UDC Project Narrative

Lombardy over CSX Bridge replacement for Walking and Biking VDOT UPC 104216

UDC Plan 2025-16

July 3, 2025

Figure 2-Proposed Typical Sections

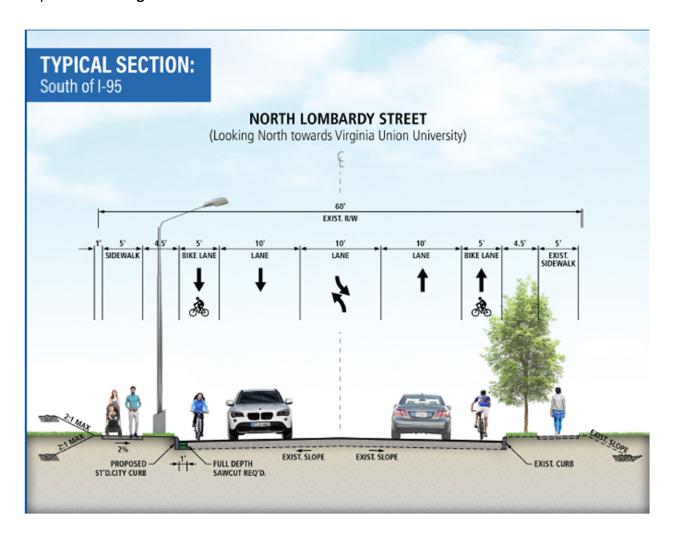
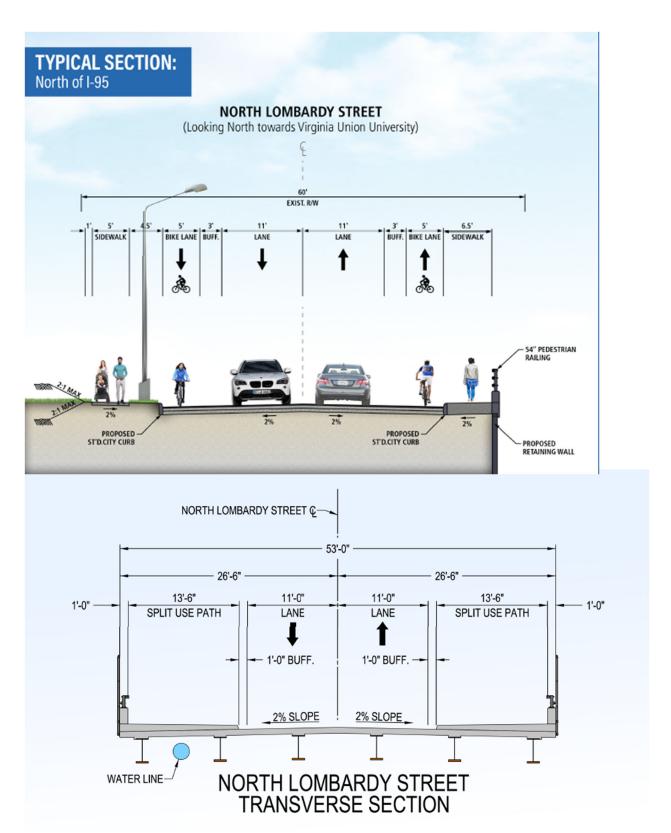
1. The UDC recommends exploring alternative treatments for the transition between the bike lane and the shared use path.

- Bike lane to remain at the sidewalk elevation across the bridge.
- Safety features will be explored and implemented to clearly delineate transitions; such items could include reflectors, signage, and pavement marking.
